CITY OF DULUTH
PURCHASING DIVISION
Room 100 City Hall
411 West First Street
Duluth, Minnesota 55802-1199
218/730-5340 218/730-5922 FAX
purchasing@duluthmn.gov

Addendum 1
File # 16-0667
Indian Point Park Mini Master Plan

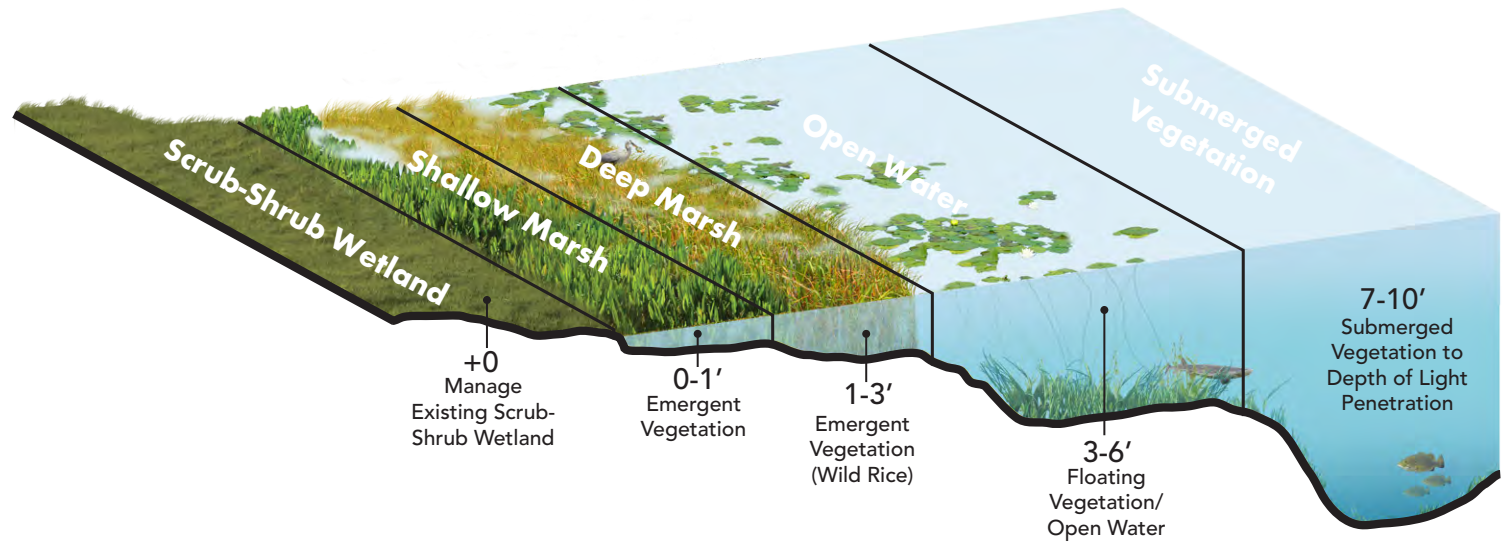
Q3 Is there a map or layout/plan available for the water and sewer utilities going into the campground?

A3 Yes.
